Subject: Addenda to APPLICATION FOR REVISION OF MINE PERMIT #C1002RE FROM STANDBY TO ACTIVE STATUS and MODIFICATION OF GROUND WATER DISCHARGE PERMIT DP-61 MT. TAYLOR MINE, SAN MATEO, NEW MEXICO, Rev.1, for Addition of Molybdenum/ Selenium (MoSe) Treatment Building

Addendum to the Application for Revision of Mine Permit #C1002RE from Standby to Active Status, Mt. Taylor Mine; July 9, 2015

Addendum to the Closeout/ Closure Plan (CCP) for Revision of Mine Permit #C1002RE from Standby to Active Status, Mt. Taylor Mine; July 9, 2015

Re: RE: Mt Taylor Mine/Discharge Permit 61 - New Mexico Environment Department comments on "Operations and maintenance manual; Mine Water Treatment Unit (MTWU) - uranium IX and molybdenum/selenium treatment facility [text and plans] (LNV, March 19, 2015)

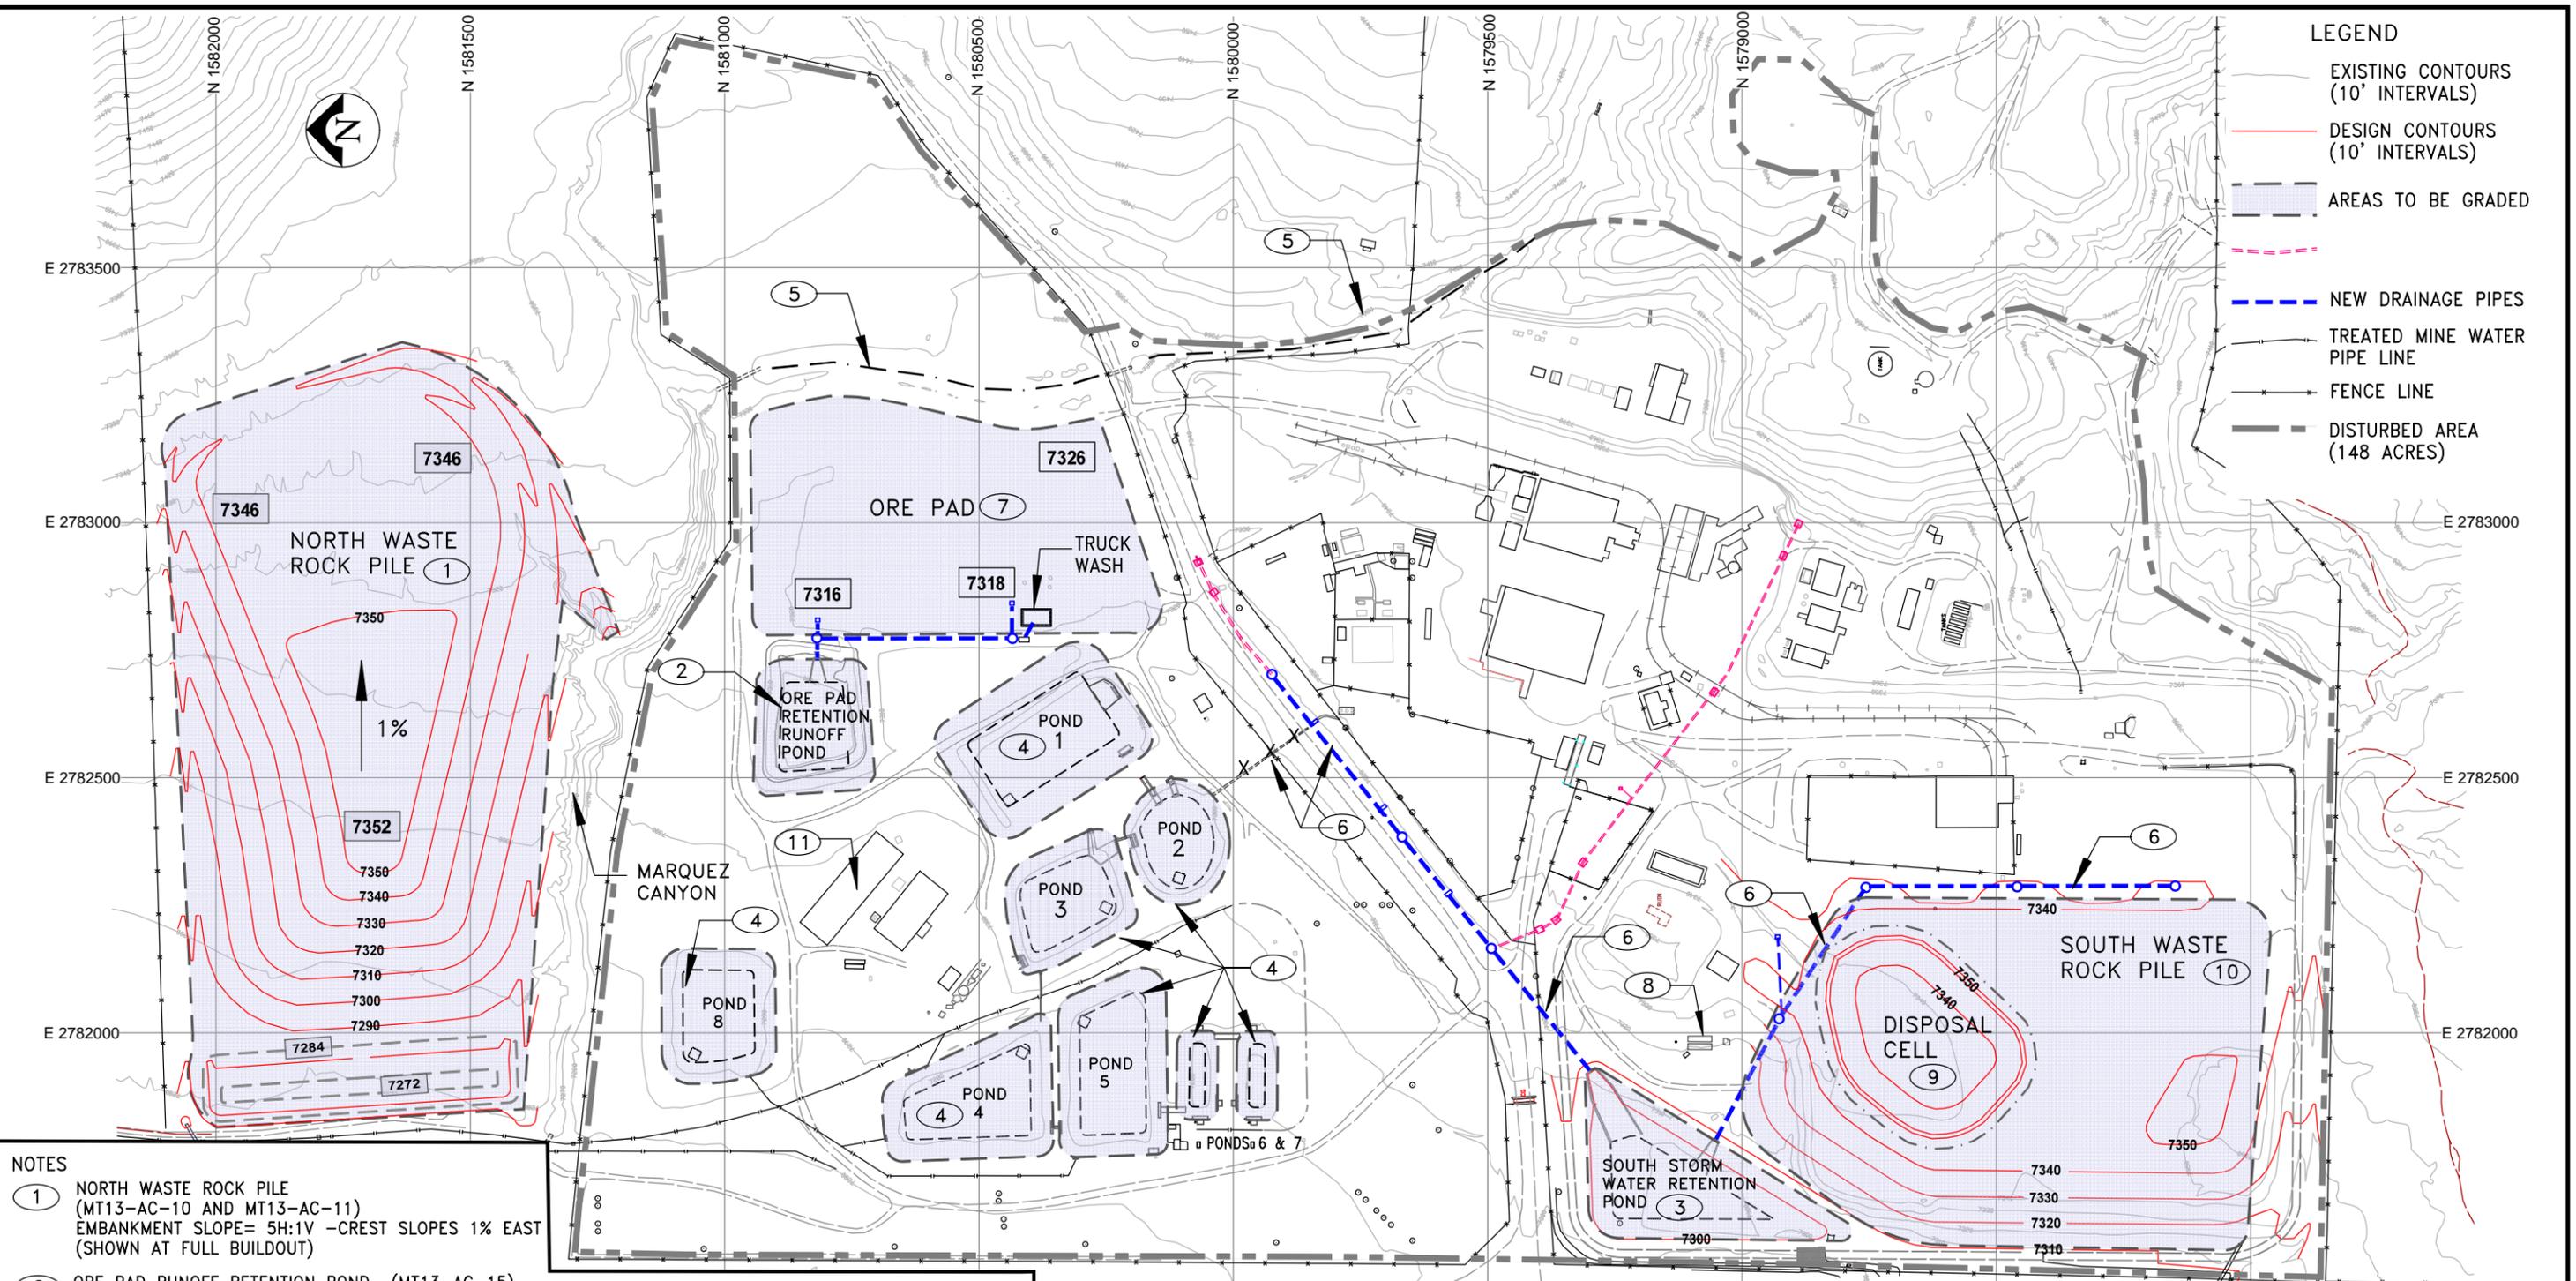
- 6 NEW DRAINAGE PIPES- FLOW REDIRECTED TO SOUTH STORM WATER RETENTION POND
- 7 ORE PAD GRADING (MT13-AC-12)
- 8 SEWAGE TREATMENT PLANT (STP)
- 9 SEDIMENT IN PONDS TO BE REMOVED AND PLACED IN DISPOSAL CELL IN SOUTH WASTE ROCK PILE
- 10 SOUTH WASTE ROCK PILE (MT13-AC-08 AND MT13-AC-09) EMBANKMENT SLOPE= 5H:1V CREST SLOPES 1% EAST (SHOWN AT REACTIVATION STAGE)
- 11 NEW MO/SE ADSORPTION BUILDING (DESIGN BY OTHERS)
